Review

FE2 Themen

EGUsphere - Monitoring and quantifying wind turbine clutter in DWD weather radar measurements

Preprint (reference for line numbers): <https://egusphere.copernicus.org/preprints/2025/egusphere-2025-4957/egusphere-2025-4957.pdf>

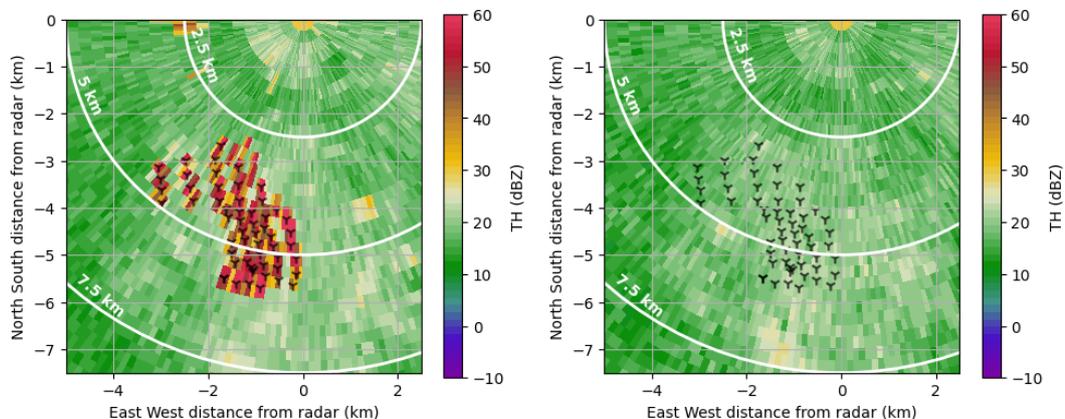
- **Figure 8:** As with Figure 3, colour bar does not correspond to the figure itself.
 - **Response:** See response concerning figure 3 above.

- **Figure 8 and Line 195:** A better example of bad coordinates from the state database might be the echoes at 127°, 8.6km
 - **Response:** Could be taken as well. In general we want to make the point, that there are quality issues with wind turbine locations from the official data bases, so we are quite happy that there is this satellite based source which can provide consistent WT locations across federal states and countries.

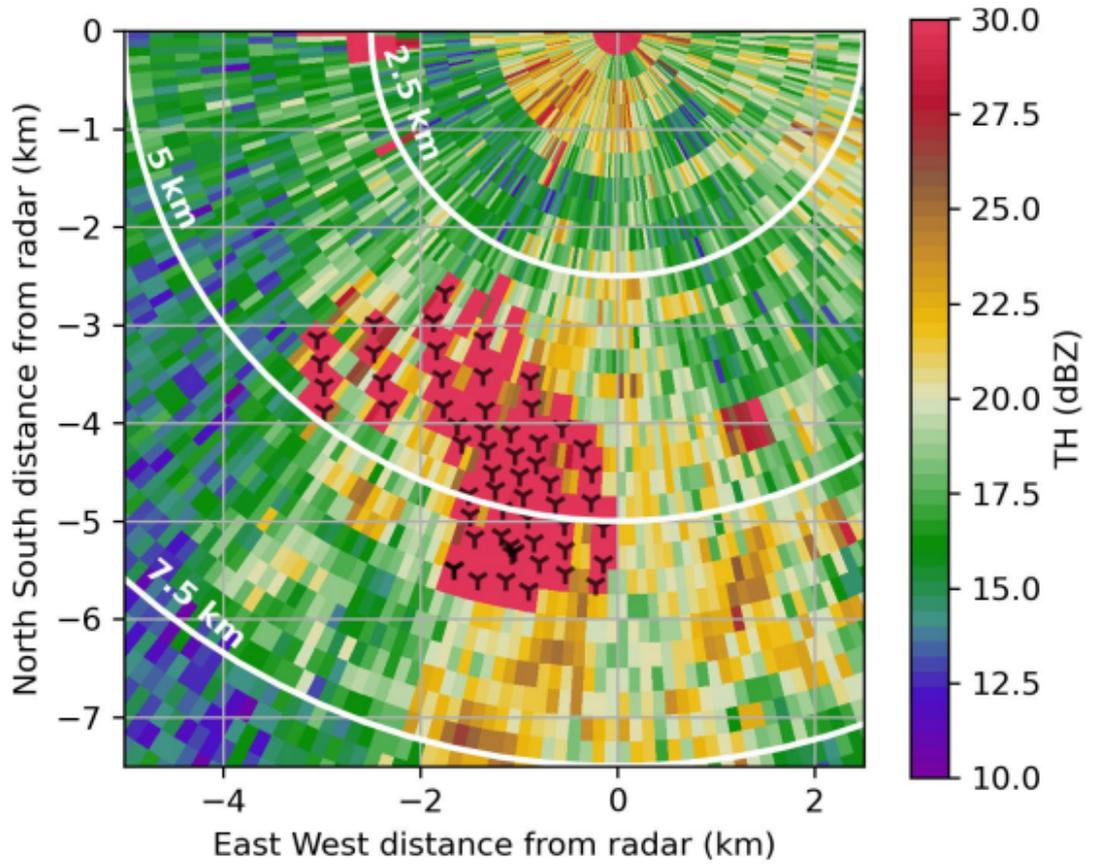
- **Figure 10:** In my opinion the upper limit on reflectivity colours should be higher. I was surprised that the turbines seemed to be spread uniformly across 3° , until I realized that the observed values were far above the colour limits; colours were saturated so no detail below 3° in azimuth. I suspect the reported reflectivities are in excess of 50 or 60 dBZ. (This links back to the remarks around line 45 but isn't really a topic for discussion in the paper.)

- **Response:** You are correct, the colours are saturated at the location of the wind turbines. Setting the range of the color bar to a range of -10dBZ to 60 dBZ (see plot below) shows this. The point that we want to convey with this figure is to show how the bins surrounding the wind farm are or aren't affected by the turbines, not so much the impact at the location of the turbines itself. Hence, we opted to use a narrower color bar range to focus on more subtle differences. Figure 13 actually contains data from the exact same time with an extended colorbar.

Coarse view of topography around TUR radar; SRTM30 data (~90m) as B-scan. Yellows are heights above 765m, which 735m ASL ground level at TUR radar plus assumed 30m antenna height. (Relates to Figure 3.)

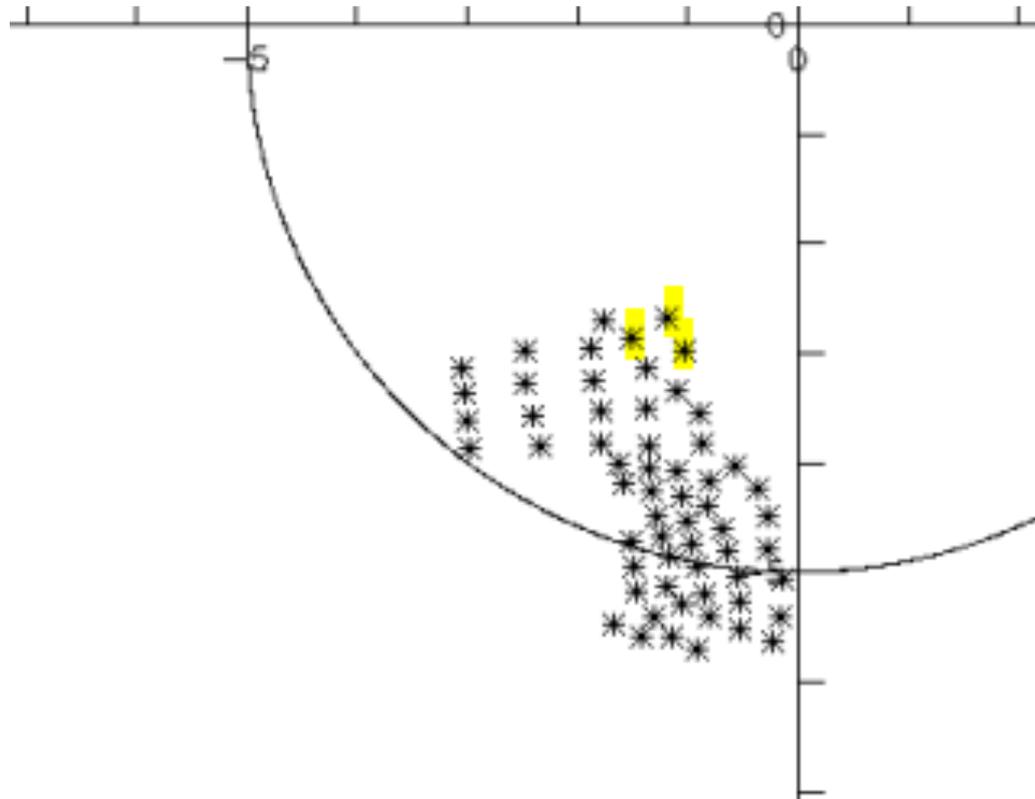
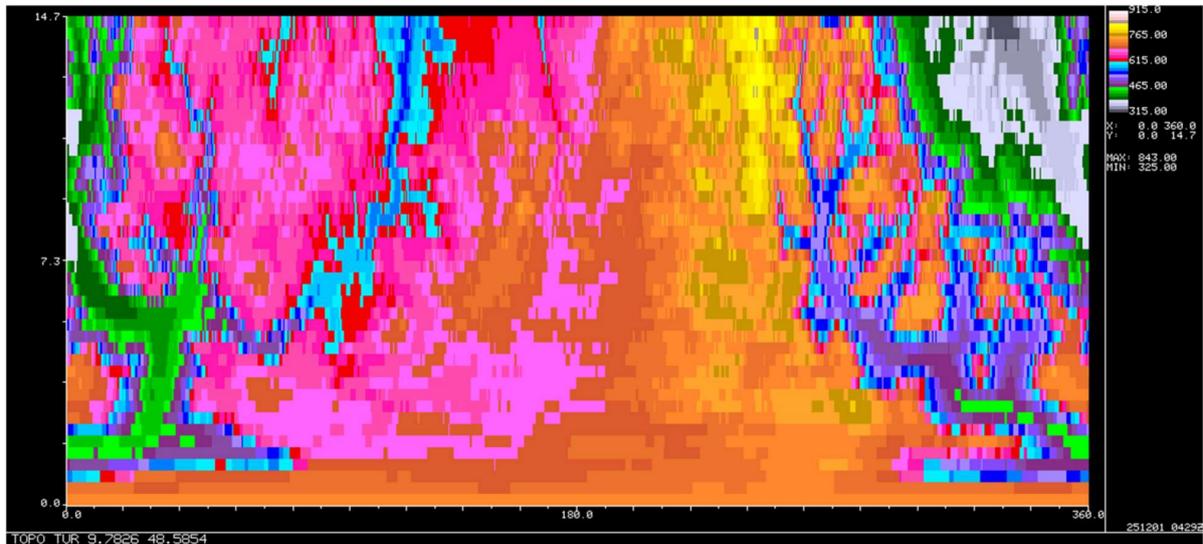
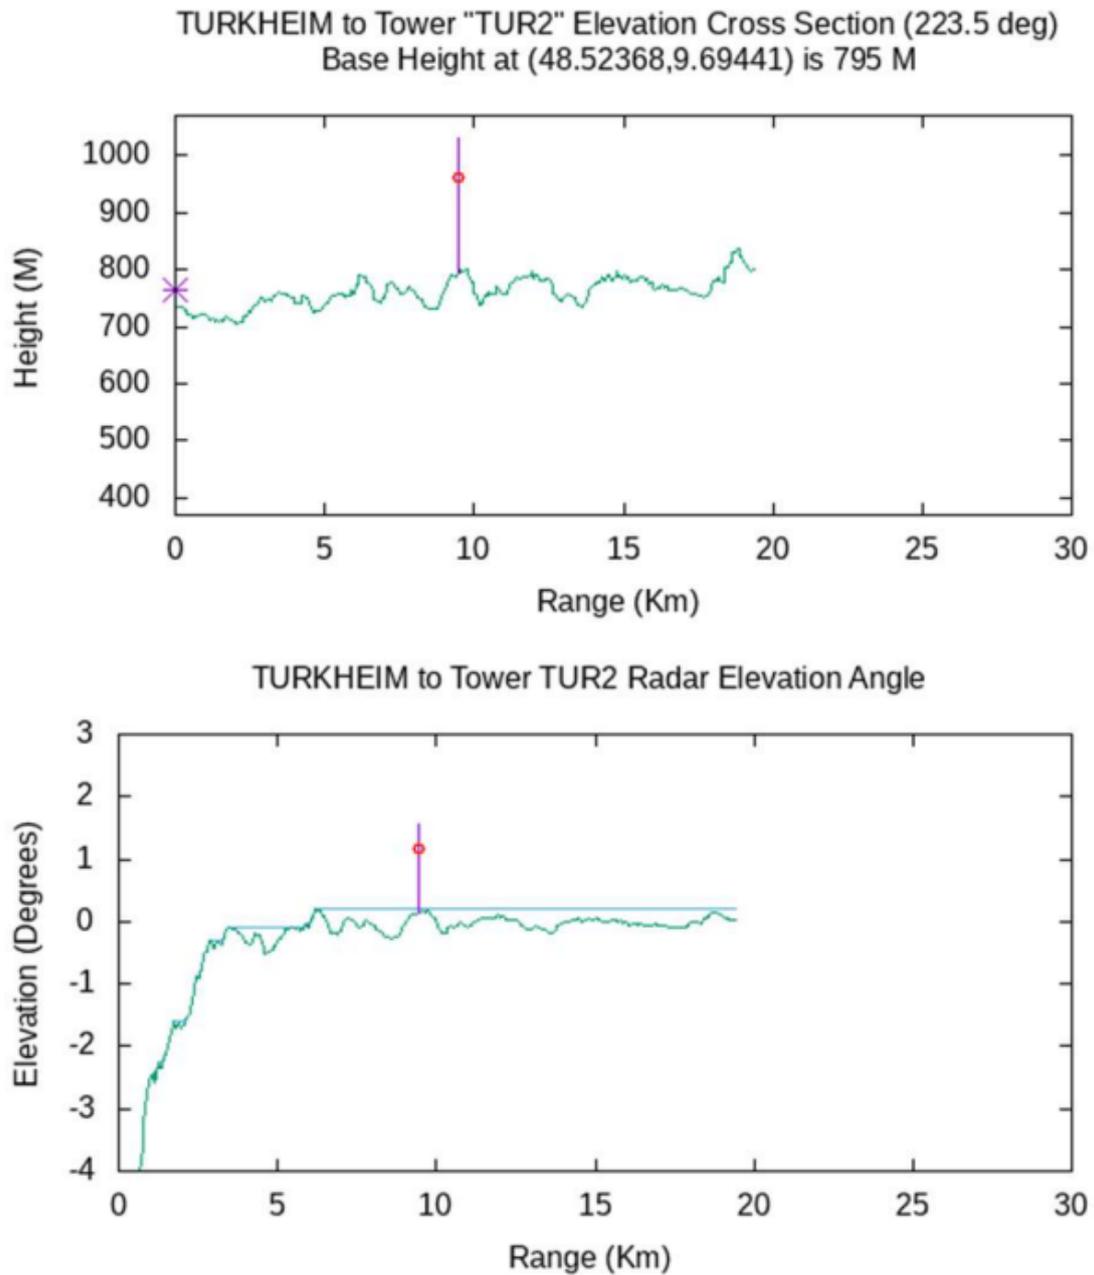
- **Response:** Your interpretation is correct.
- **Figure 3:** The colour bar does not correspond to the figure. The colour bar shows pure grays, but the figure is using colours with a magenta/purple shade. The figure is deceptive because it implies the radar antenna is higher than all surrounding terrain. Google Earth says the ground height is about 800m at turbines TUR2 and TUR3, and the height at the radar is about 735m. That means the antenna would need to be at 65m above ground to equal the ground height at the turbines. Maybe the radar is that tall?! <See comment about providing details of the radar siting.>

Figure 3: The colour bar does not correspond to the figure. The colour bar shows pure gray colours, but the figure is using colours with a magenta/purple shade. The figure is deceptive because starting at 0m implies the radar antenna is higher than all surrounding terrain. Google Earth says the ground height is about 800m at turbines TUR2 and TUR3, and the height at the radar is about 735m. That means the antenna would need to be lower than the ground at that location, unless the antenna is more than 65m above ground. (Maybe the radar is that tall? The radar site specifications are not given.) My version of the figure using a crude topography database is below.

- **Response:** Thanks a lot for pointing this out! You are correct: antenna center height is 767,62 m, the total height of those wind turbines is about 1022 m (with respect to sea level); the height of the topography is 788 m. We accidentally limited the plotted range between -200 and 0 m, we now plot terrain height in a range between -200 and 100 m.
